- D – wheel replacement
- SC66XX X

<b>Bulletin #:</b>	<b>FG01006</b>
<b>Bulletin Date:</b>	<b>August 1, 2006</b>
<b>Subject:</b>	<b>D-wheel replacement</b>
<b>Affected Model(s)</b>	<b>SC66XX X</b>

Fig.1 New

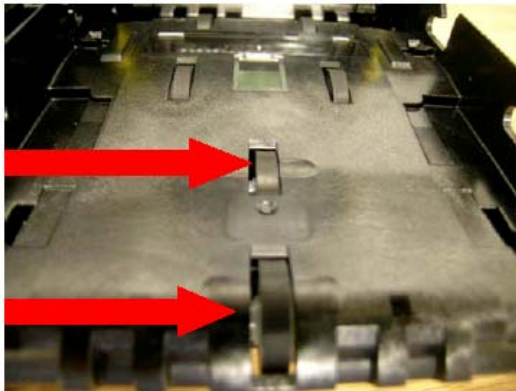
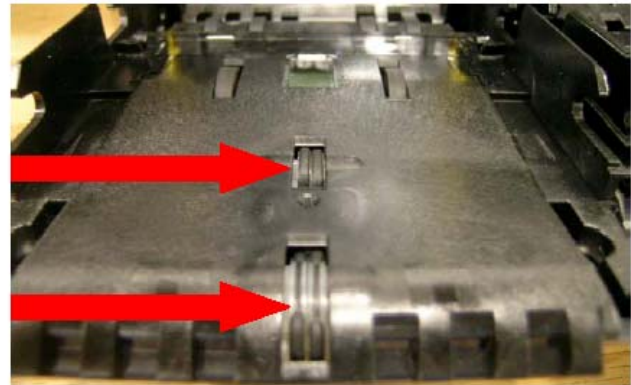
The “D” wheel design used in the SC/SCL series of bill acceptors has been replaced with a simpler wheel design in the 66mm platform. The design intent of the “D” wheel was to help center notes in a multi-width platform (SC83 and SC85). As the 66mm platform is a fixed-width platform, it has been verified that the centering function of the “D” wheel in the 66mm platform is not required. Ultimately, the new wheel design has been introduced to simplify our manufacturing process for the 66mm product while maintaining product performance. All 66mm units manufactured June 20<sup>th</sup> and after will have the new wheel design. Figures 1 and 2 show the new design versus the old.
